ADDENDUM NO. 1

February 16, 2024

Yorktown High School – Addition and Renovations 1100 South Tiger Drive Yorktown, IN, 47396

ADDENDUM

1 ENLARGED FLOOR PLAN
A220 SCALE: 1/4" = 1'-0"

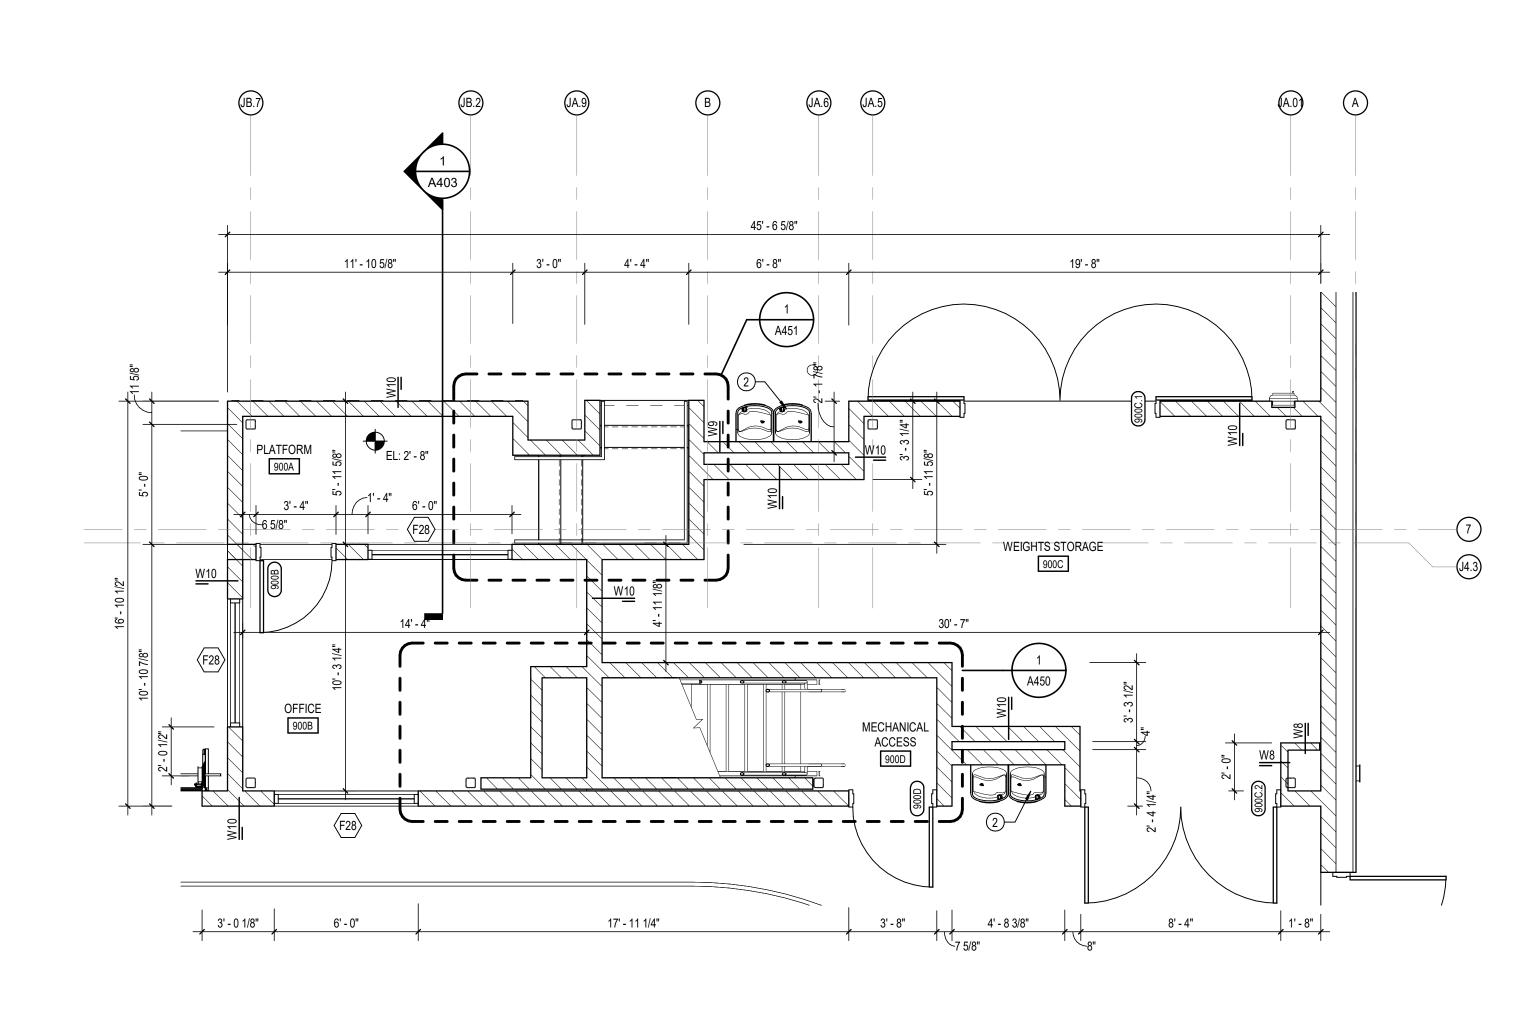
3.18 <u>A220 – ENLARGED FLOOR PLAN</u>

A. Issue new sheet in its entirety.
